American General Aircraft Corporation

CRITICAL SERVICE BULLETIN

SB No. 183

SUBJECT: PARKER HANNIFIN WHEEL AND BRAKE " MASTER CYLINDERS"

FIGURE 1

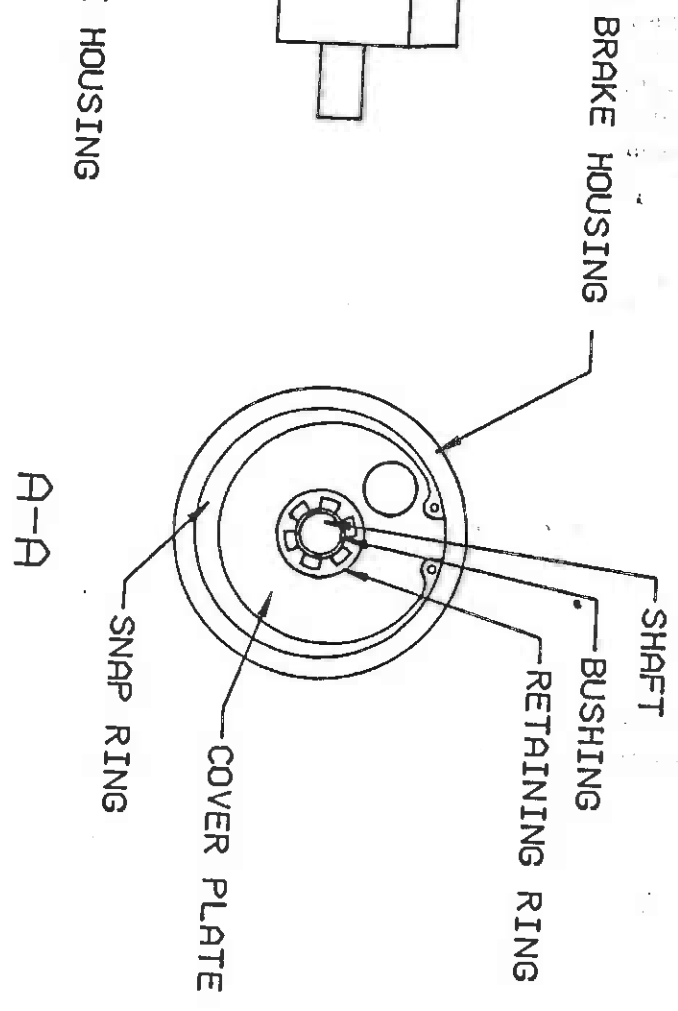
1. Prepare the aircraft for safe maintenance.
2. Remove the right and left master cylinders in accordance with the AA-5 series Maintenance Manual and the AG-5B Supplement Chapter 32-4-2.
3. Inspect the piston shaft guide bushing in the cover plate for security and wear. (Reference FIGURE 1)
4. If the inspection above reveals that the clearance between the guide bushing and the piston shaft is in excess of .015 inch, or the guide bushing can be rotated in the cover plate, the cover plate assembly must be replaced.

1. Remove the clevis and clevis lock nut from the piston shaft. Note the location of the clevis for reinstallation.
2. Install the retaining ring P/N 155-06900 by sliding the retaining ring (with the inner beveled teeth up) over the piston shaft and simultaneously pulling on the shaft and pushing on the retaining ring to force the ring over the bushing. Make sure that it is on as far as possible. (A "C" channel installation tool would be helpful in this task)
3. Reinstall the lock nut and clevis to its original location.
4. Reinstall the master cylinder in accordance with the AA-5 Series Maintenance Manual and the AG-5B Supplement Chapter 32-4-2.
5. Record compliance with this Service Bulletin in the aircraft log and return the aircraft to service.
6. Complete the attached compliance card and mail to:

RETAINING RING
 P/N 155-06900
